River District Design Commission

**MAY 14, 2020
4:00 P.M.**

AGENDA

604 Wilson Street - Danville, VA | Elliott Electric Office Exterior Renovations

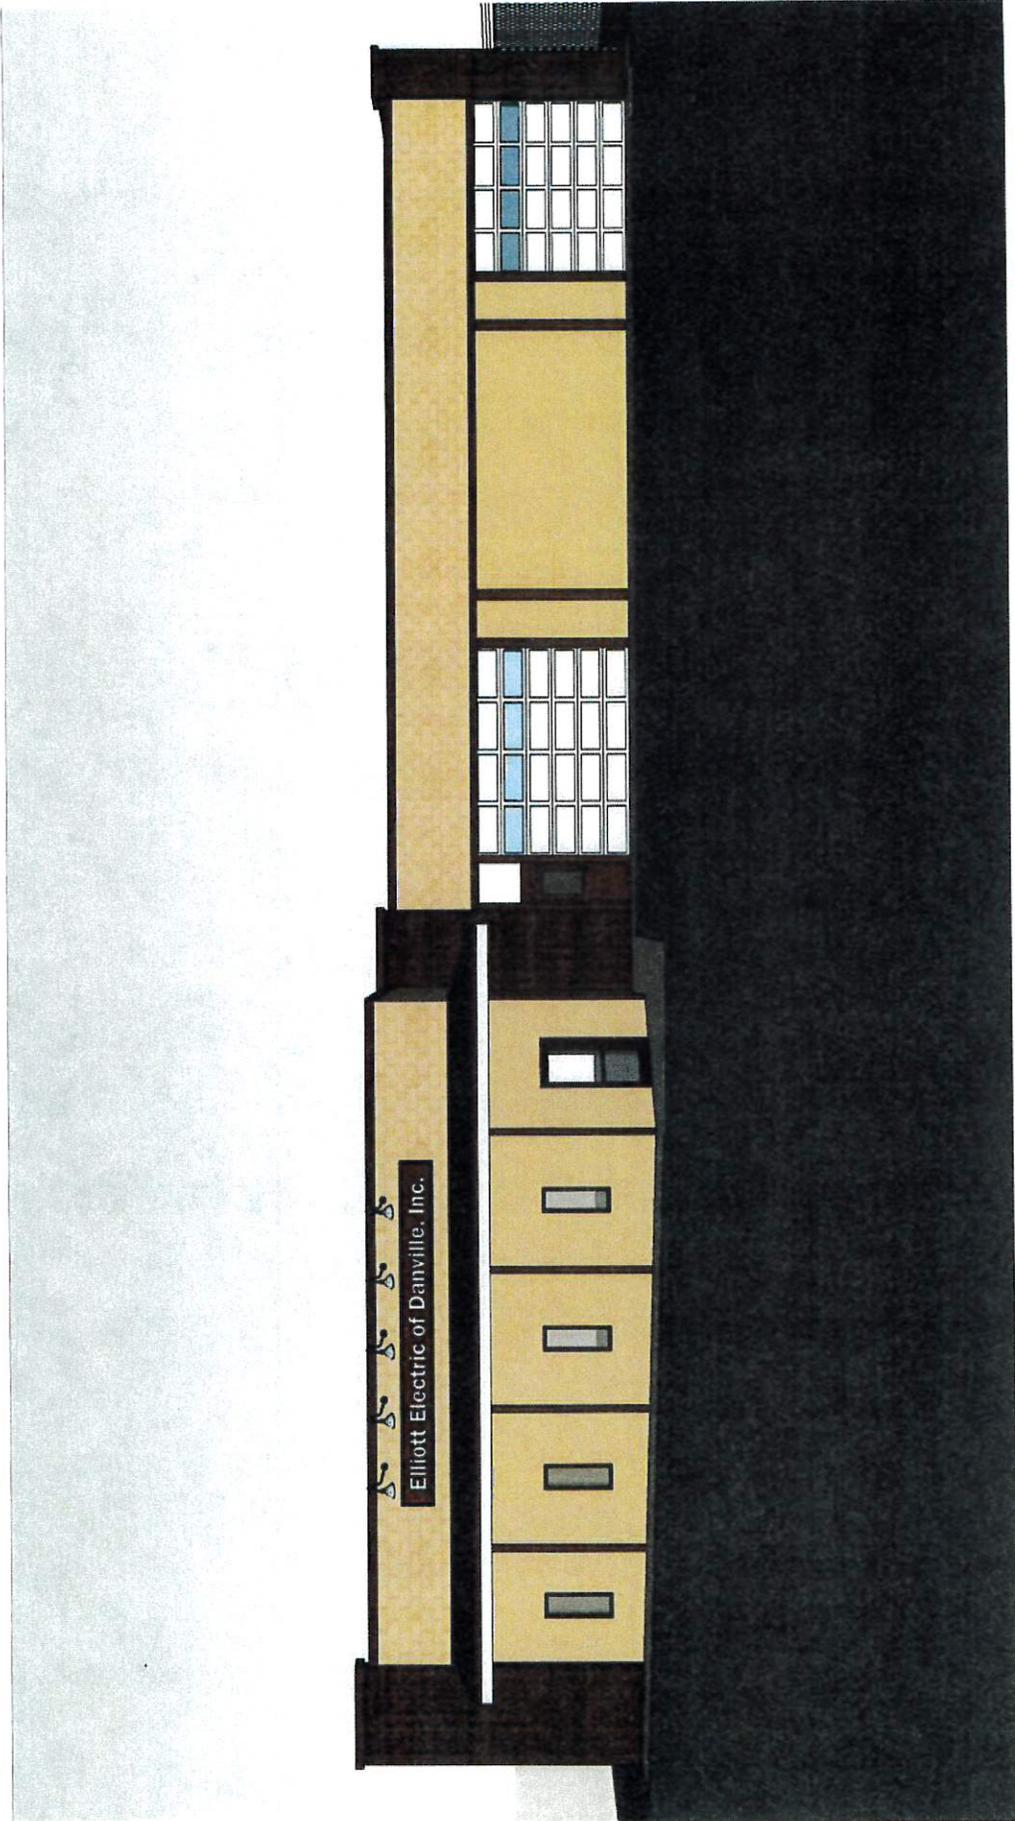
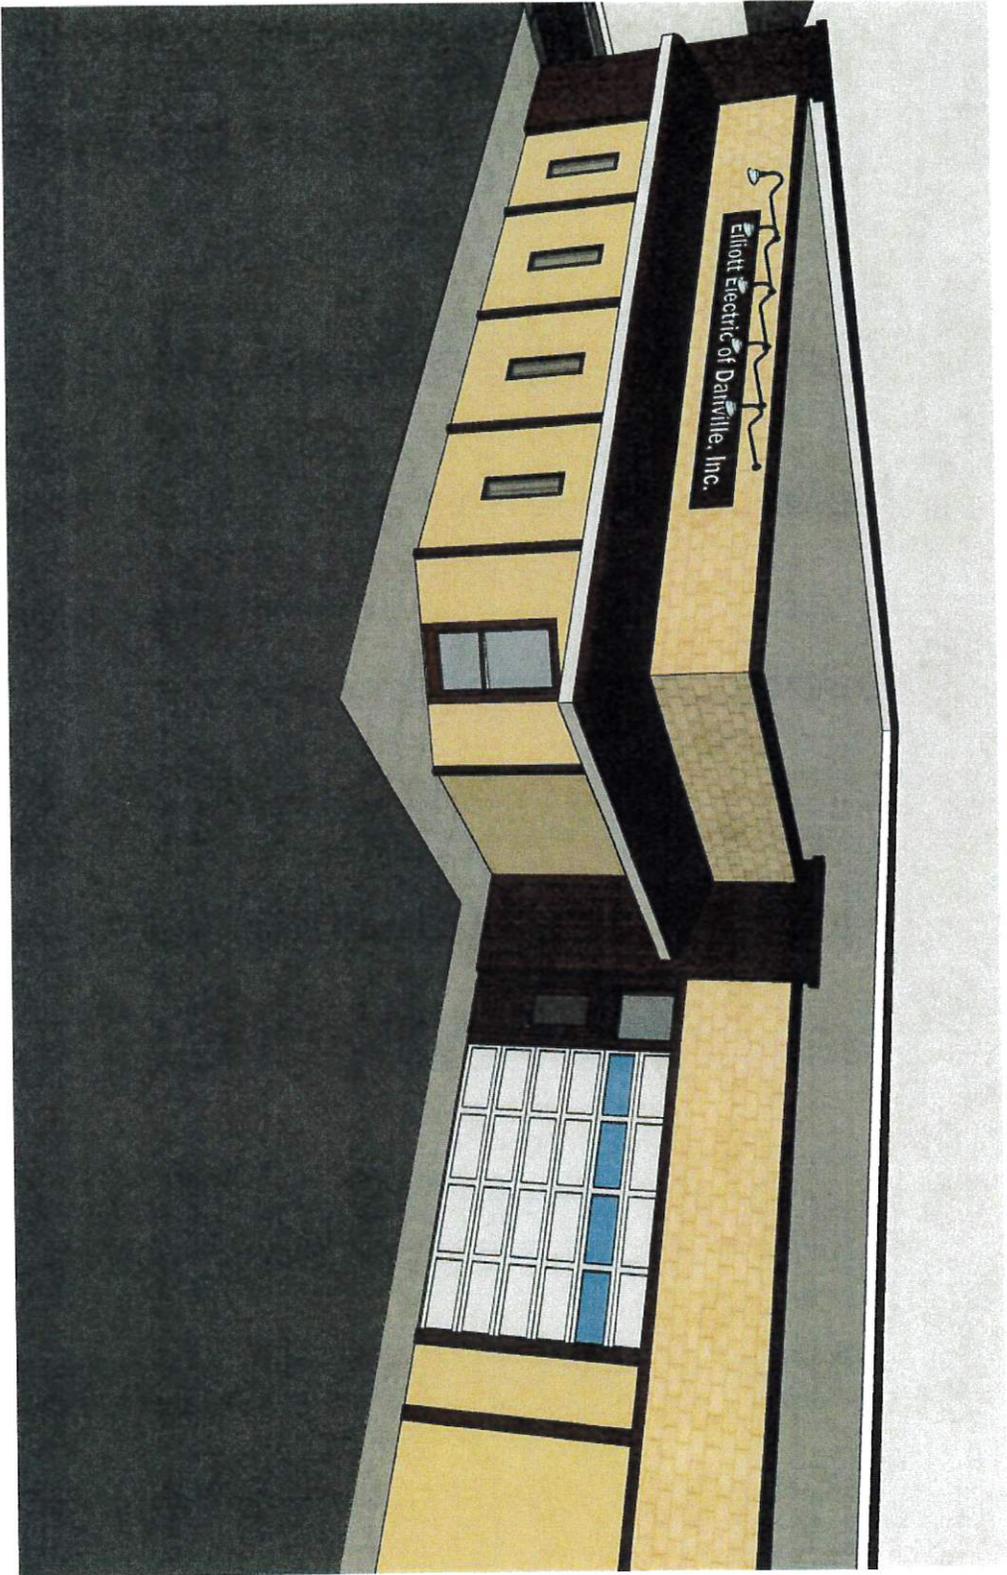
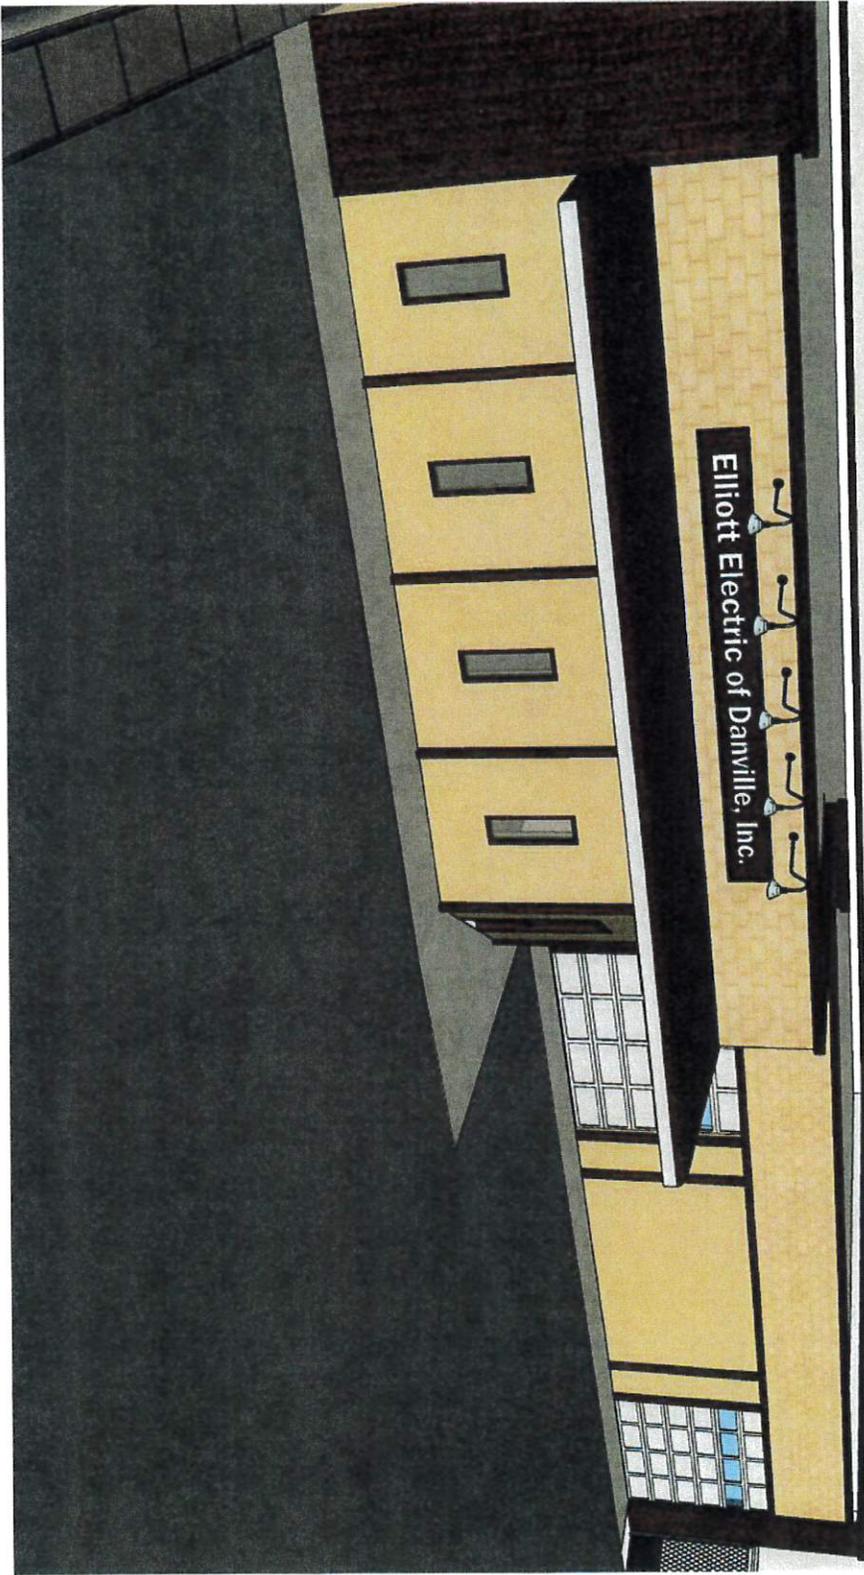
What materials will the sign be made out of? Are the windows wood, aluminum or fiberglass?

Do you have a list of materials that you are proposing to use? How large is the sign, what size are the windows, what color will the paint be, awnings will be made of what?

Windows are bronze aluminum . Sign will be painted metal

The windows are 18" x 5' and will be bronze metal frames. The front will be covered with eifs stucco except where brick is existing and the whole building will be repainted as close to the tan and mocha that is existing. The sign is approximately 3' x 15'. The awning is metal on metal frame similar to one pictured here <https://www.wayfair.com/outdoor/pdp/awntech-houstonian-8-ft-w-x-3-ft-d-metal-standard-window-awning-awnt3546.html> but pitched like what was sent in the rendering (probably around 10 degree pitch).

OPTION B - 214 & 216 N. UNION ST.

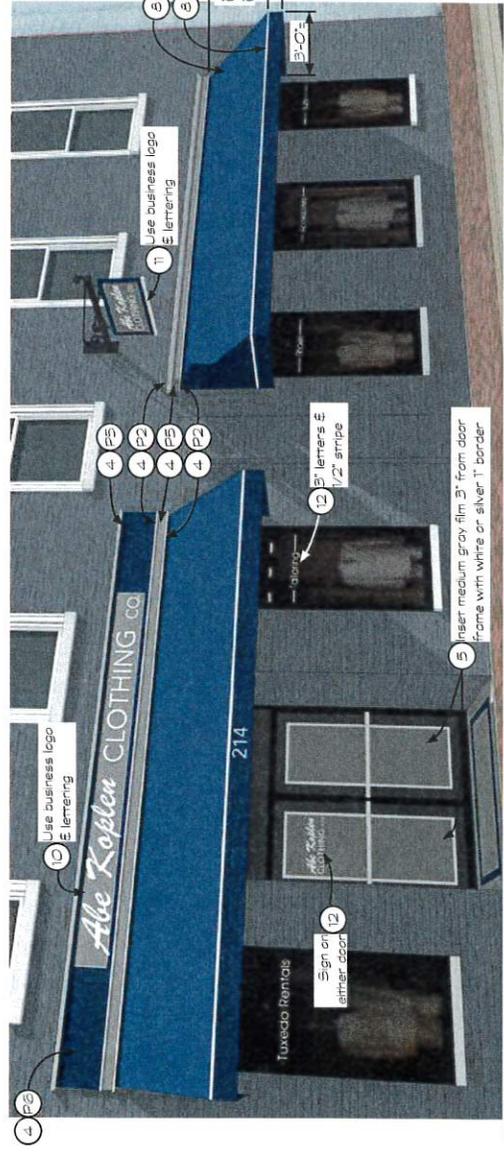
More information to be included with Mr. Koplan's request since applicants are not allowed to be there to speak in person about specifics. For reference is the rendering that the original COA was issued for.

CHANGES REGARDING FAÇADE PLAN DATED 7/11/2018, #86002AA30 for 214 N. UNION STREET

- 1) As mentioned, a carpenter will revive the left side of the building. Once that work is completed, the painting will follow the plan as detailed. (please note: the Abe Koplen sign over the left side's double doors will be cleaned, its borders painted, and a new and better quality glass panel will be installed. Likewise, new plexiglass panels will be made for the door panels.)

- 2) Signage on the other, larger part of the building (214) will be eliminated. So will the awnings and the window treatments. However, the color chosen for the awnings will be used to accentuate the windows.

- 3) The quality of the paint will be the best available. All paint colors on the original drawing will remain the same. Painting will follow the application of a sealer that will strengthen and solidify both the very old mortar as well as the antique bricks.--

Item A. The request is to remove awnings and not reinstall. Awnings are not a code requirement so staff is not opposed to this.

Item B (painting of brick storefront) requests to repaint an existing storefront to match the other proposed renovations at on this property. Staff recommends the Commission issue a Certificate of Appropriateness at 214-216 N Union St. to repaint the existing brick storefront using the colors provided on the application (Downing Slate, Jubilee, and Dignity Blue).

Item C (trim to replicate a simple cornice) requests to install a new feature which adheres to the design guidelines and matches the surrounding area, if wood is used. Staff recommends the Commission issue a Certificate of Appropriateness at 214-216 N Union St. to install new trim to replicate a simple cornice with the following condition:

- The trim will be made with wood.
